Item ID: D2580-1 Accept *N900040100* Setup Start *NS1*
 Revision ID: Stop *NS2*
 Item Name: 205 Skidtube bent detail
 Start Date: 01/03/2012 Start Qty: 2.00 *2* Cust Item ID:
 Required Date: 05/03/2012 Req'd Qty: 2.00 *2* Customer:
 Reference:

DRAWING NO. D2580	TITLE 205 SKIDTUBE ASSEMBLY	REV. E	DART AEROSPACE LTD ENGINEERING ORDER	D.E.O. NO. D2580-E-1	SHEET NO. SHEET 1 OF 1	SCALE NTS
DRAWN <i>UP</i>	CHECKED <i>ASS</i>	MFG. APPR. <i>ER</i>	APPROVED <i>#</i>	DE APPR. <i>#</i>		
DATE 11.12.13	DATE 11.12.13	DATE 11.12.13	DATE 11.12.13	DATE 11.12.13

CHANGE ALL C'BORED WELDED CROSSBOLT SPACERS TO SWAGED SPACERS

D5-2
SECTION B-B
SCALE 5X

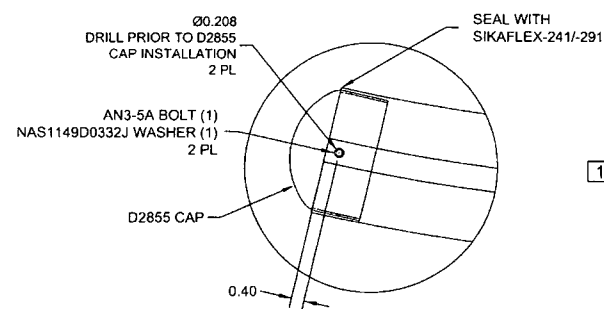
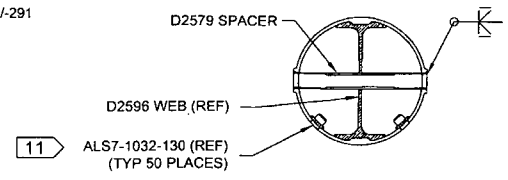
SECTION B-B, SECTION F-F, & SECTION I-I ARE AMENDED AS FOLLOWS
FOR ALL HOLES THAT WERE ORIGINALLY C'BORED:

1. INSERT D4202-1 SPACER, 20 PL (-041) OR 20 PL (-045) OR 25 PL (-047)
2. SWAGE TO Ø0.437 X 1.00 DEEP PER QSI 002
3. TRIM / GRIND FLUSH PER QSI 002

SECTION B-B, F-F, I-I
NOT TO SCALE

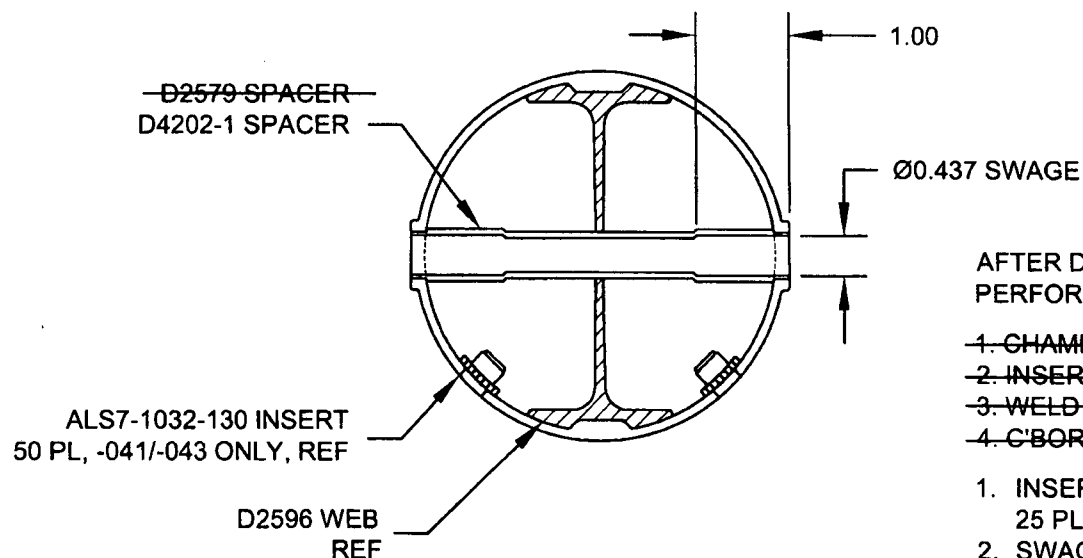
AFTER DRILLING AND BENDING ASSEMBLY
PERFORM THE FOLLOWING FOR Ø0.508 HOLES ONLY:

1. CHAMFER HOLE 0.050 X 45°
2. INSERT D2579 SPACER (20 PLACES)
3. WELD INTO PLACE AND GRIND FLUSH
4. C'BORE D2579 SPACER TO Ø0.437 X 1.00 DEEP
